ADDENDUM #3

August 27, 2025

**CRAWFORDSVILLE READINESS CENTER MODERNIZATION
INDIANA NATIONAL GUARD
CRAWFORDSVILLE, INDIANA**

IFB NO: MDI-SAB-26-B-013

ABI 1
A120

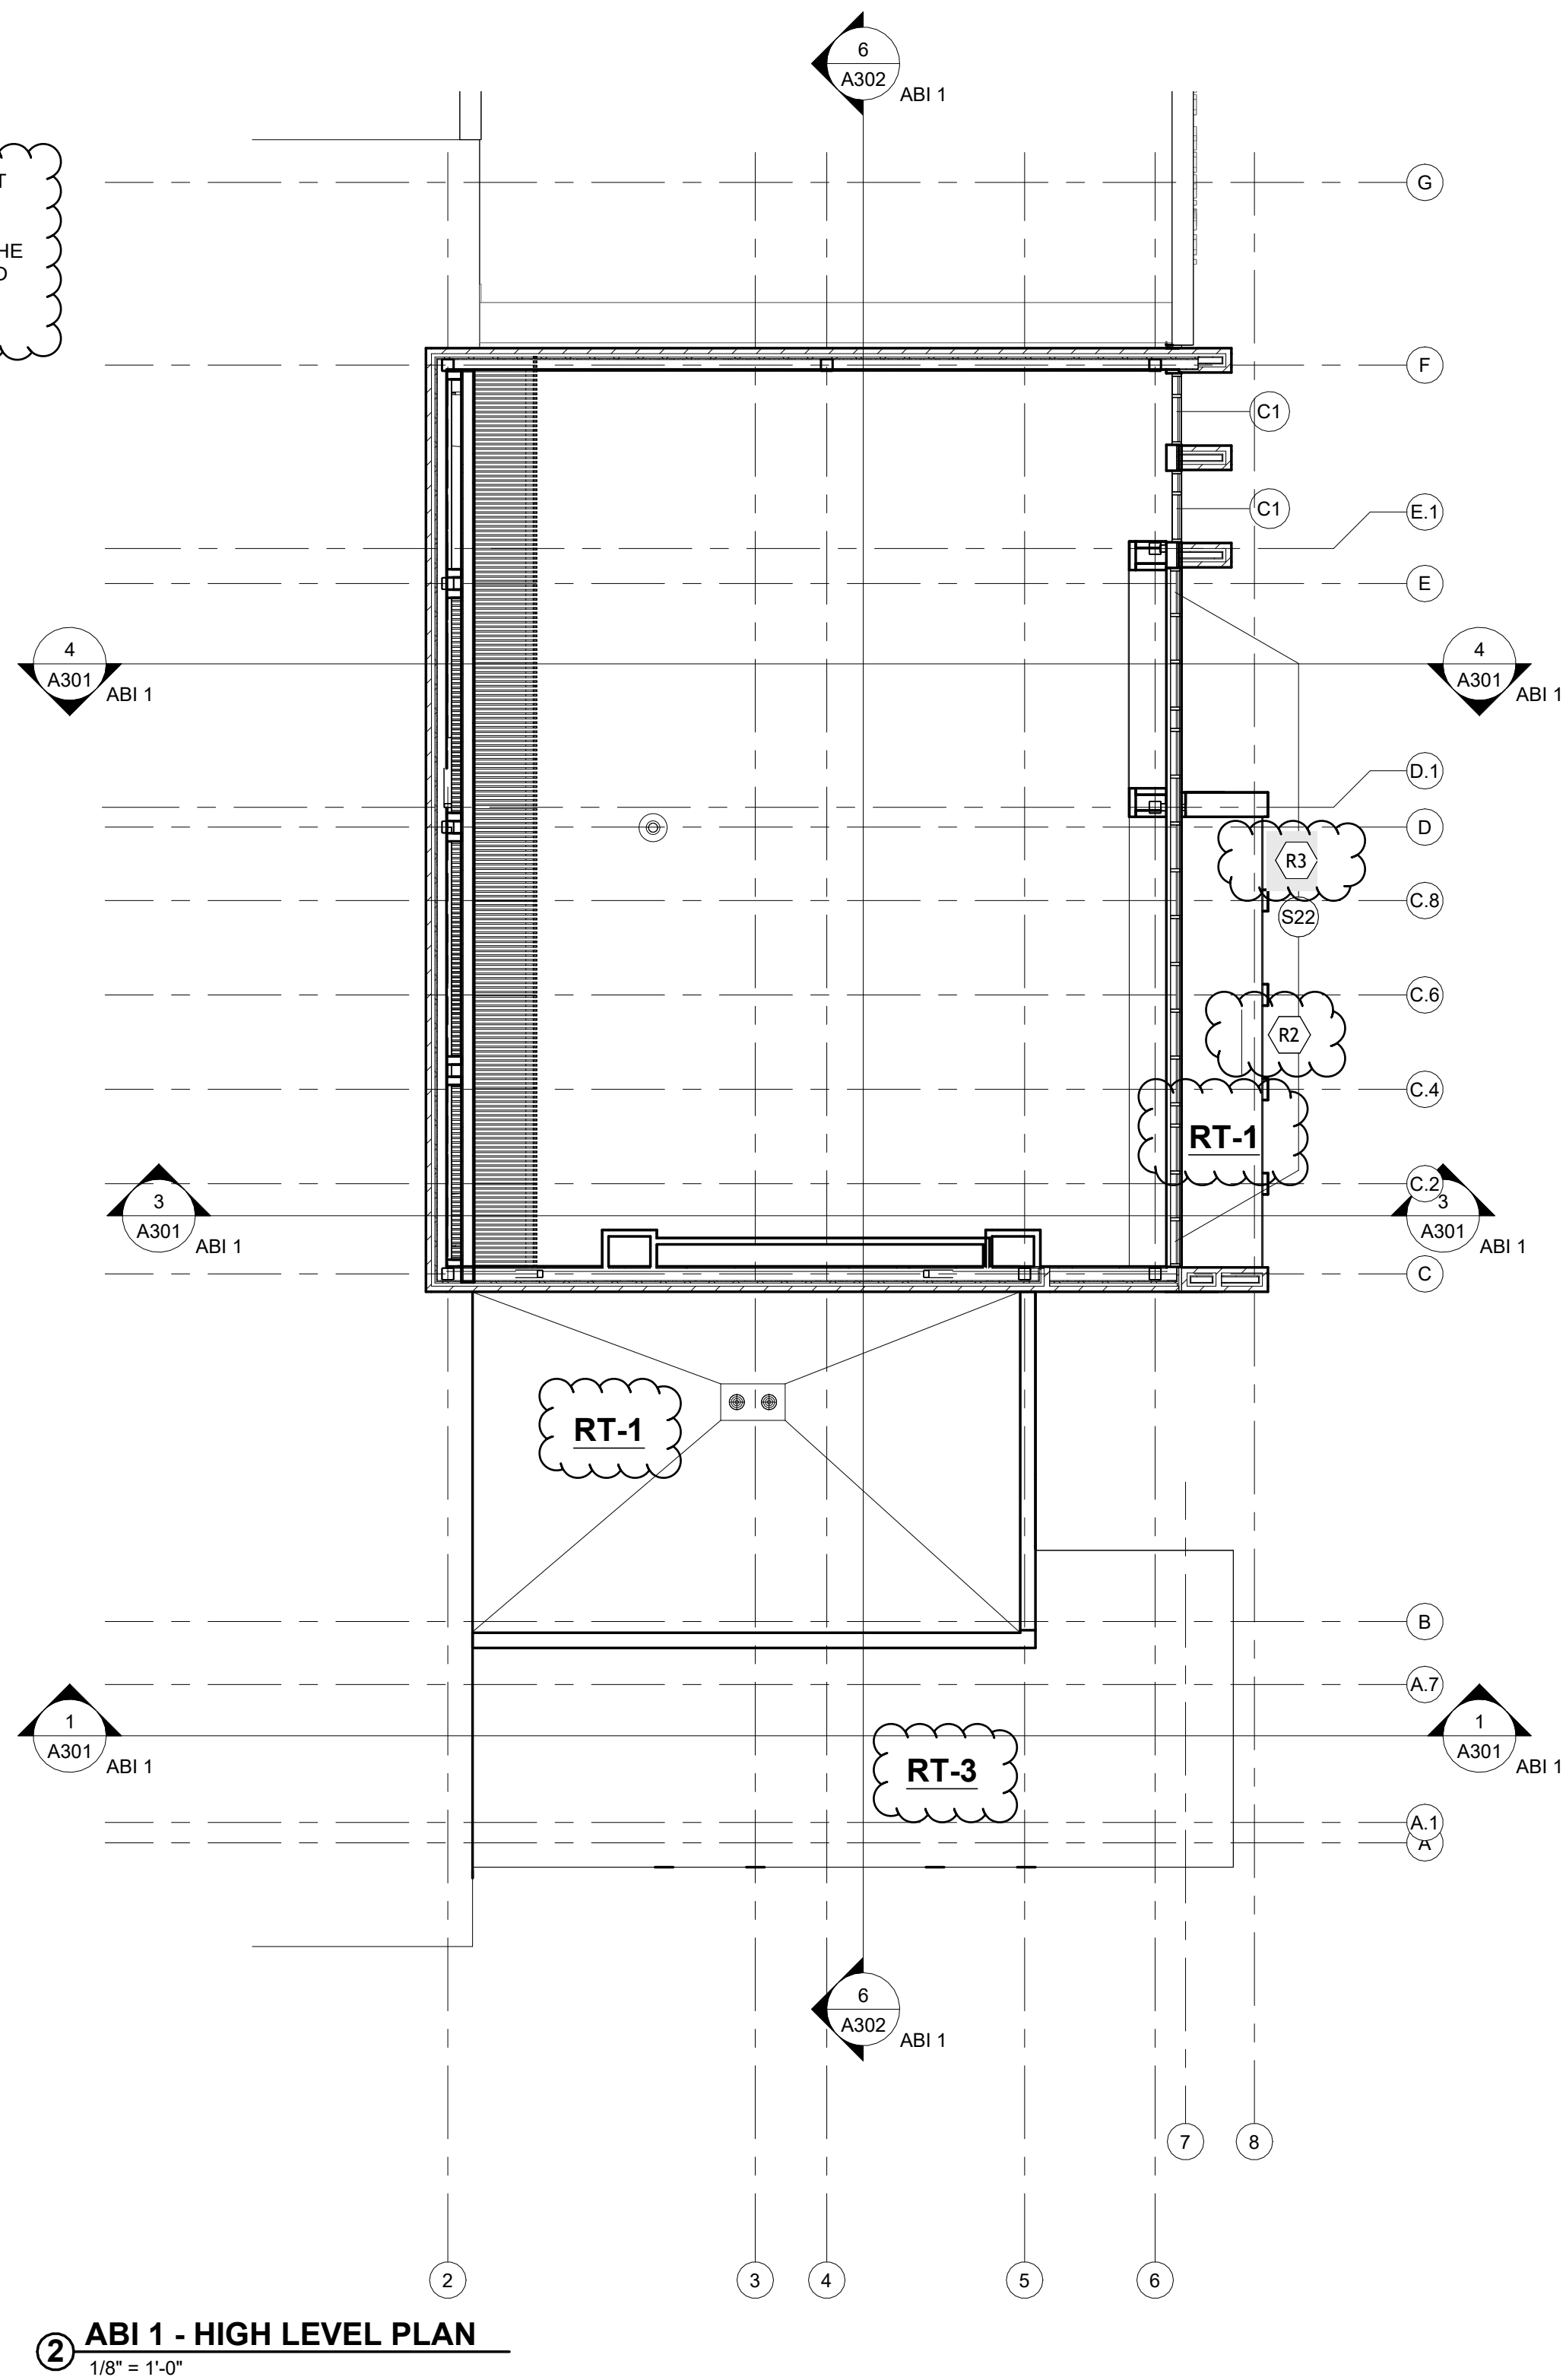
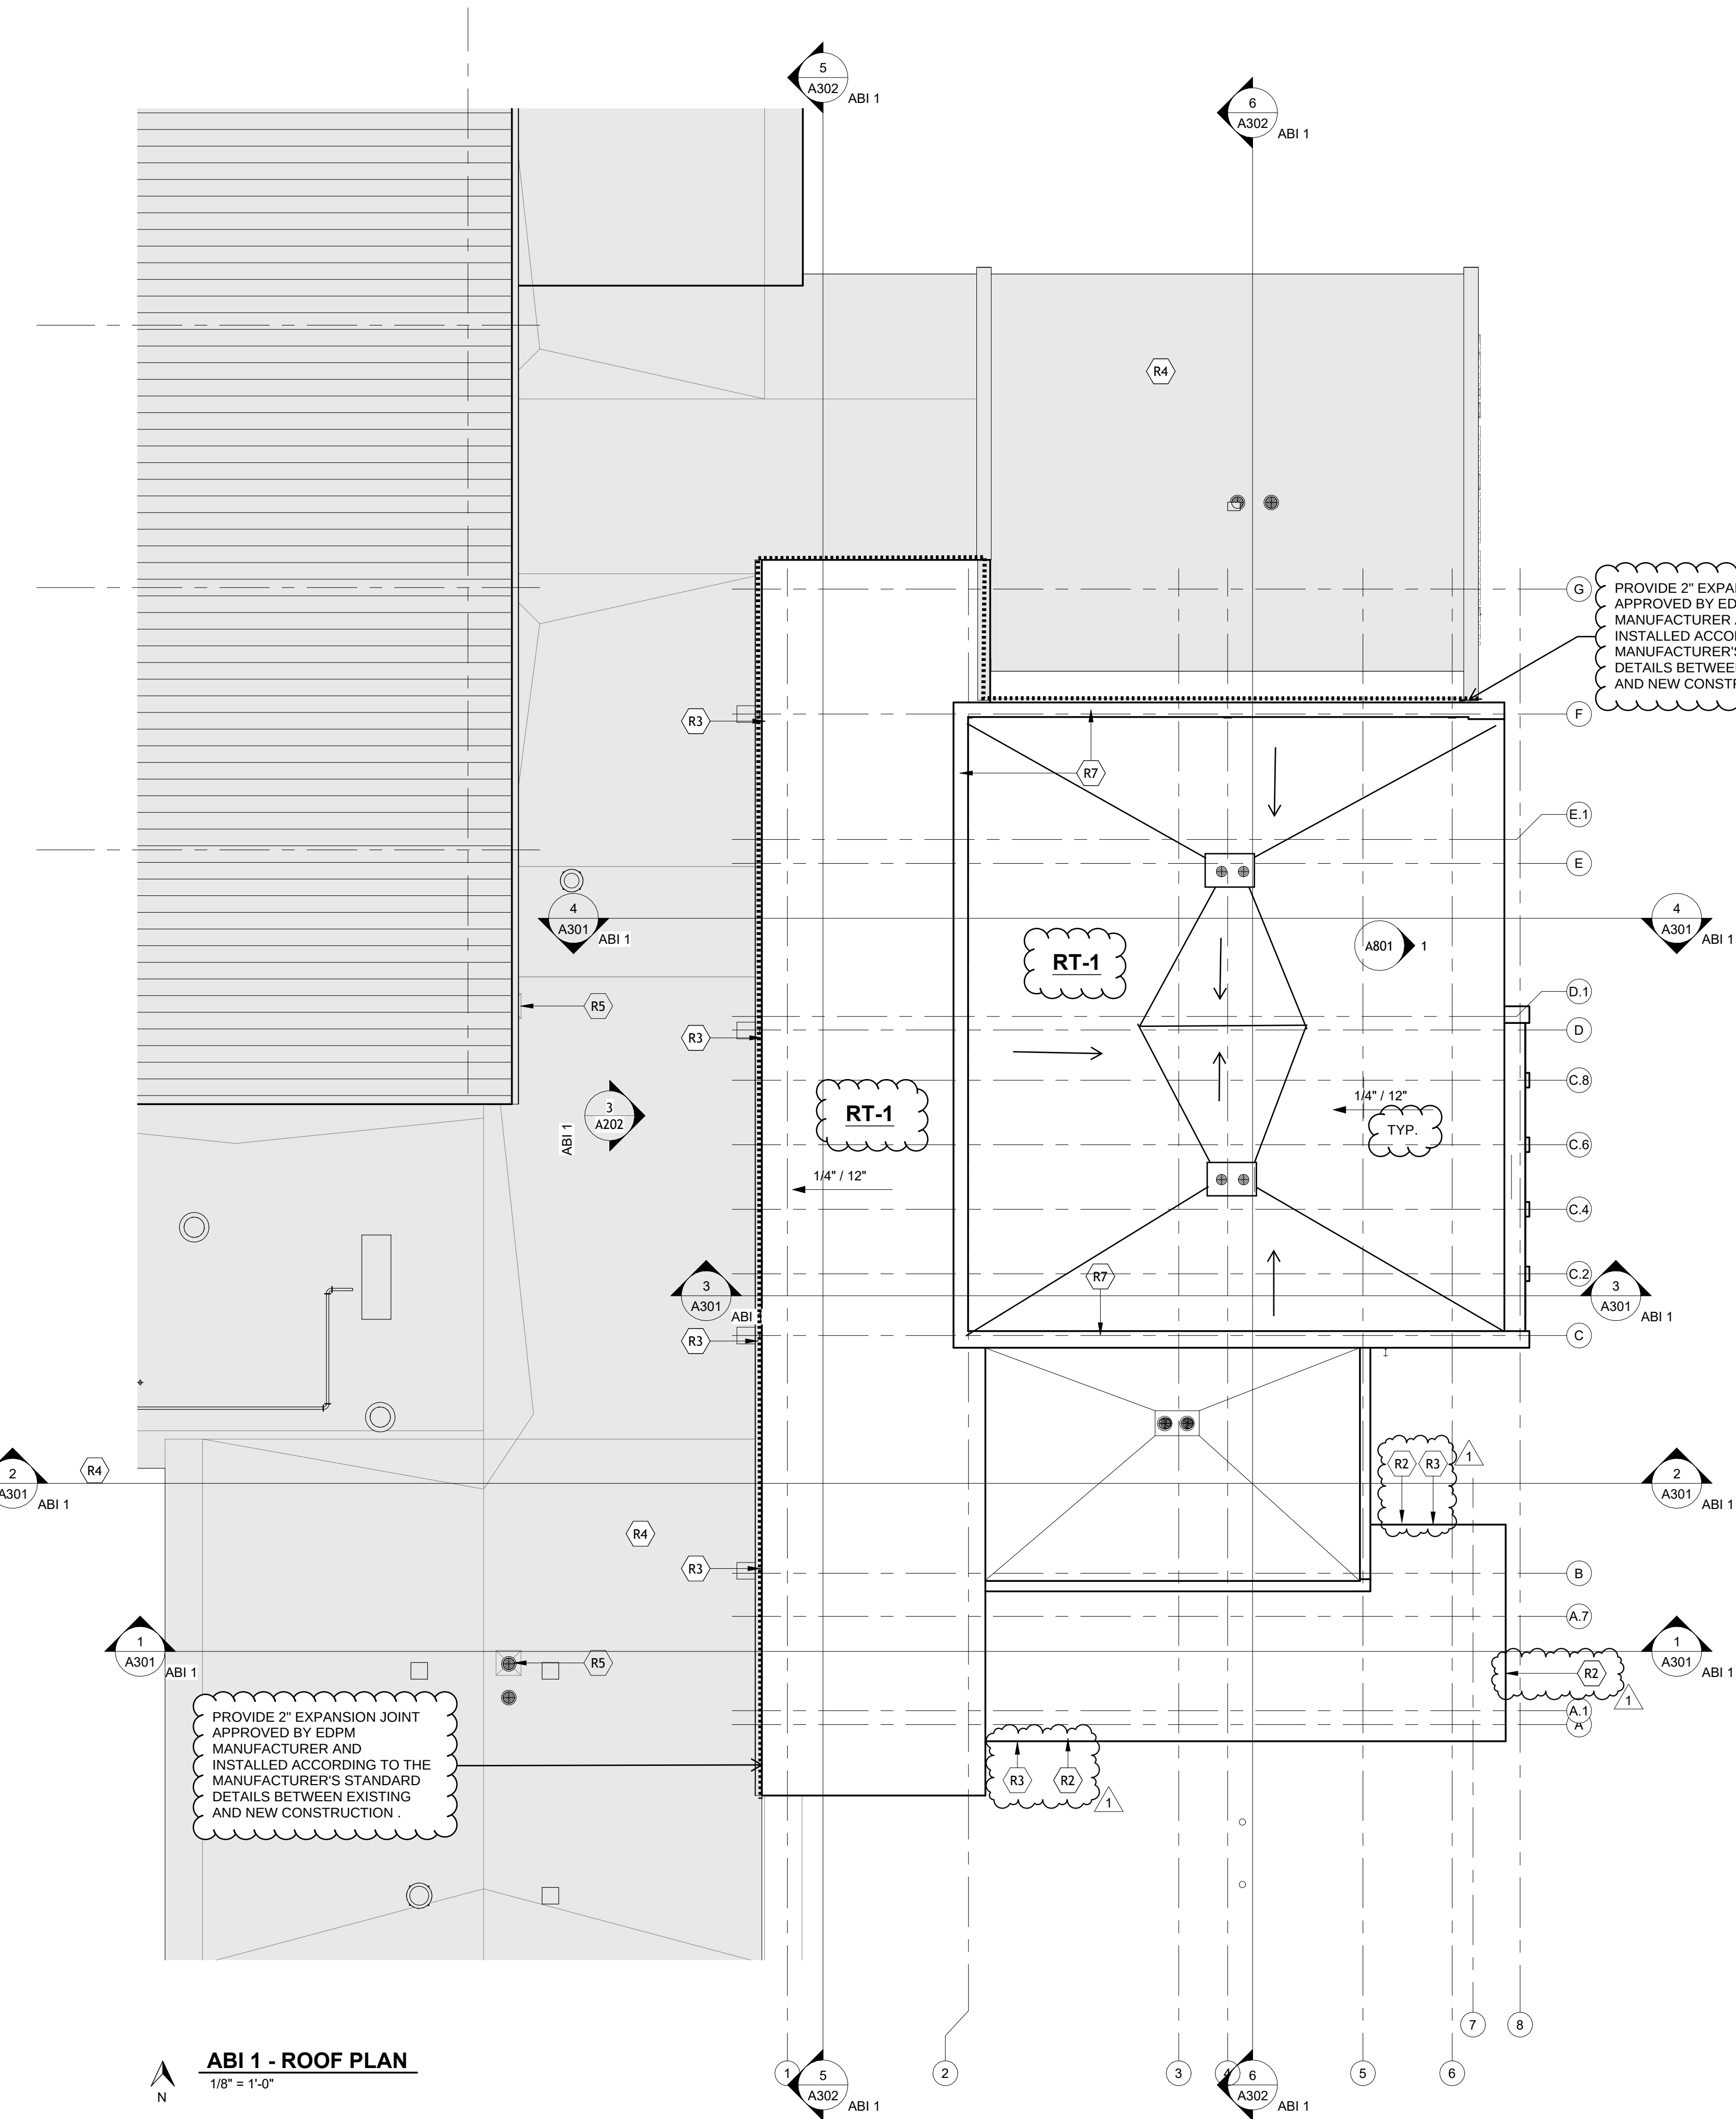
- b. Update Building Section References.
- 10. Sheet ABI 1 A120 – ABI 1 ROOF PLAN
 - a. Add keyed notes to the canopy roof.
 - b. Add roof type tags.
 - c. Update Building Section References.
